# Town of Poughkeepsie

### A.5. 51 VASSAR ROAD

**SEQRA Review, Site Plan Review, and Architectural Review** for the redevelopment of a parcel to include construction of a ±10,640 square foot building for retail use. 51 Vassar Road; Red Oaks Mill Neighborhood Services Center (ROMNSC) Zoning District; ±4.58 acres; Grid #: 6260-04-565213; Unlisted Action; *Calito Development Group, LLC c/o Matt Eucalito (Applicant) and Oak Mill Plaza LLC c/o Vincent Destaso (Owner)*.

**Re: Amended Site Plan for Calito Development Group, LLC**  
**51 Vassar Road, Poughkeepsie, NY 12603**  
**Parcel ID #134689-6260-04-565213**

8 WATER METER PIT  
NOT TO SCALE

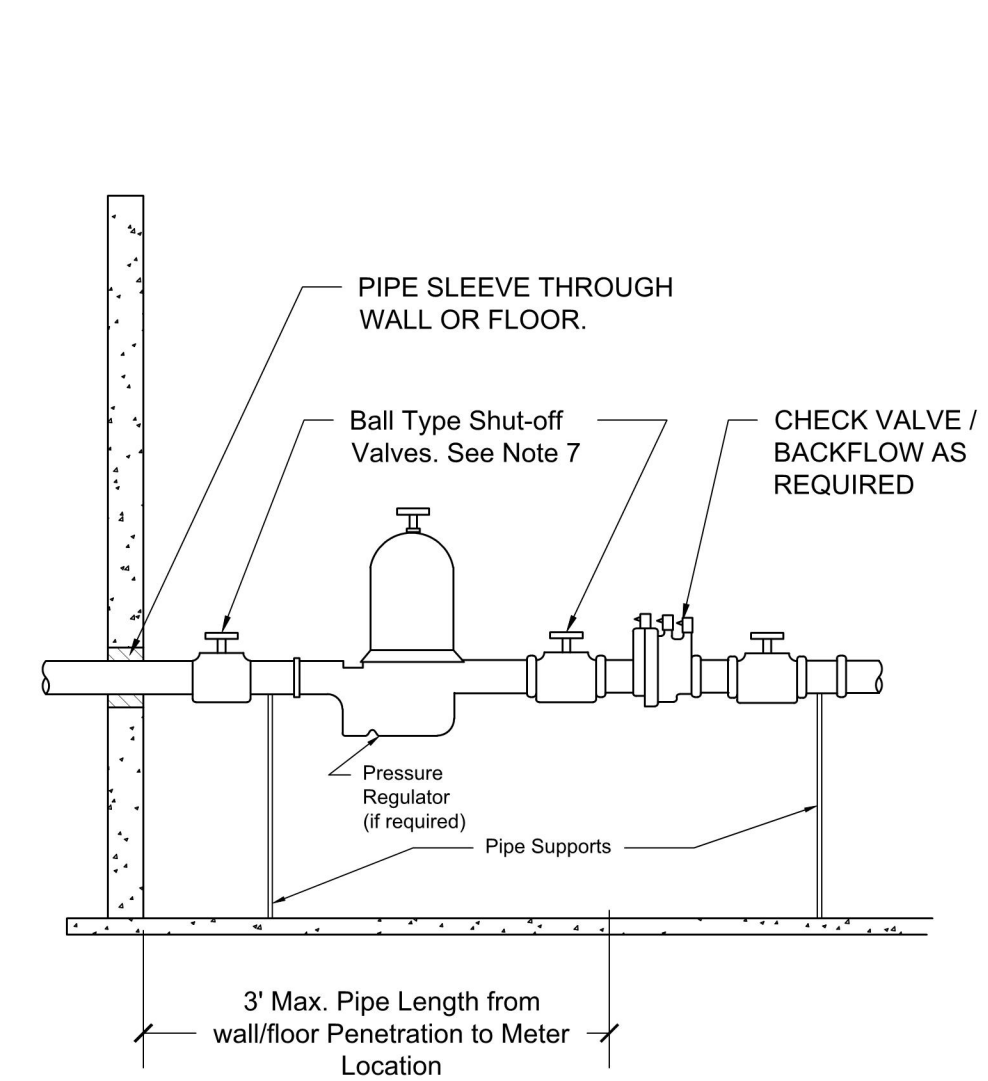
Your utility plans call for 2" diameter copper for the domestic water feed. After the meter pit, you have the option of using plastic tubing to the building. Longer lengths of means less liabilities associated with copper couplings. Your 2" Sensus meter will include a strainer in front of the meter, so make sure the pit is sized correctly. Bury a 6' length of 4" diameter PVC pipe vertically and tighten against the pit exterior wall to install the wire in the pipe, and the radio transmitter on out side for meter reading.

a. Provide a pit-setter water meter detail, contact the Water Department for all requirements.

**Response: A pit detail has been added to the details.**

**Response: A detail has been added for consideration.**

1 PHOTOMETRIC PLAN  
1" = 40'

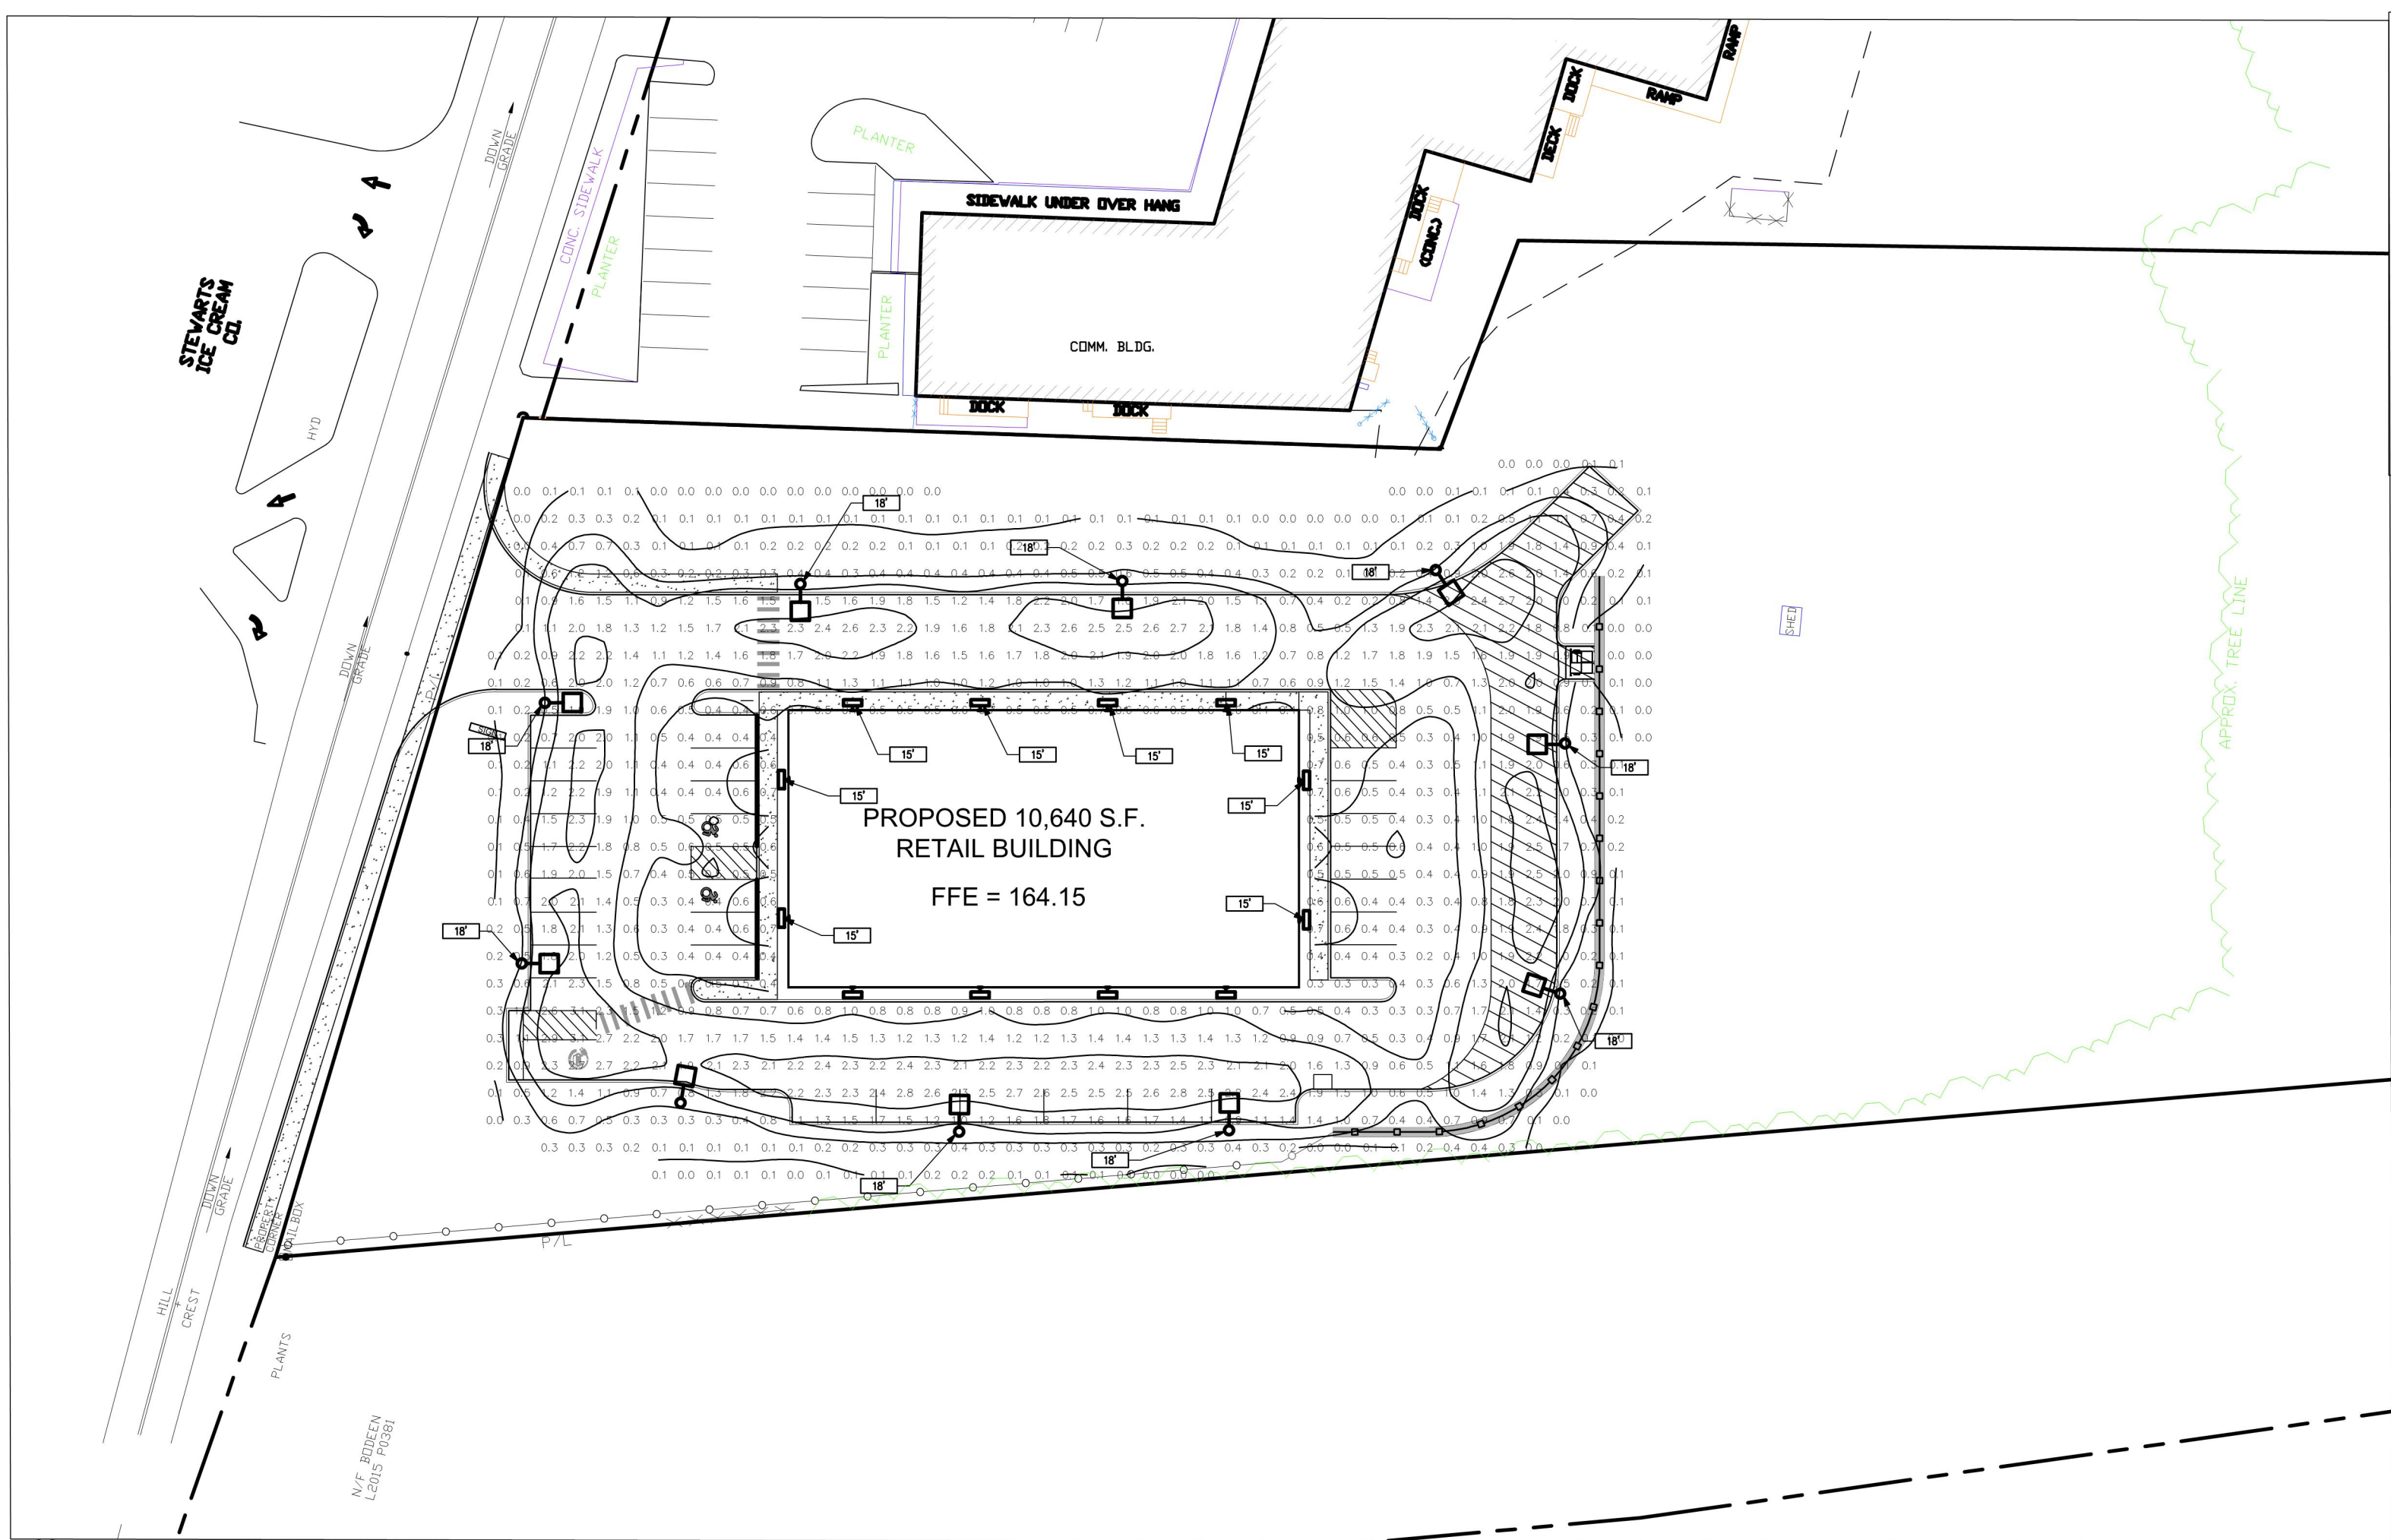
- a. Applicant to note that there is a tree proposed near this monument sign that may hinder visibility. Confirm planting locations here.
14. Sheet LL101: The photometrics plan sheet appears incomplete. Applicant to provide photometrics to the property line. Applicant to review outputs at the southeast corner of the lot. Per Town Code §210-81, the cutoff for this parcel at the property line is 0.2 footcandles. However, the property to the south of this parcel is located in the R-20 zoning district and therefore consideration to get the footcandles to 0.0 should be given.
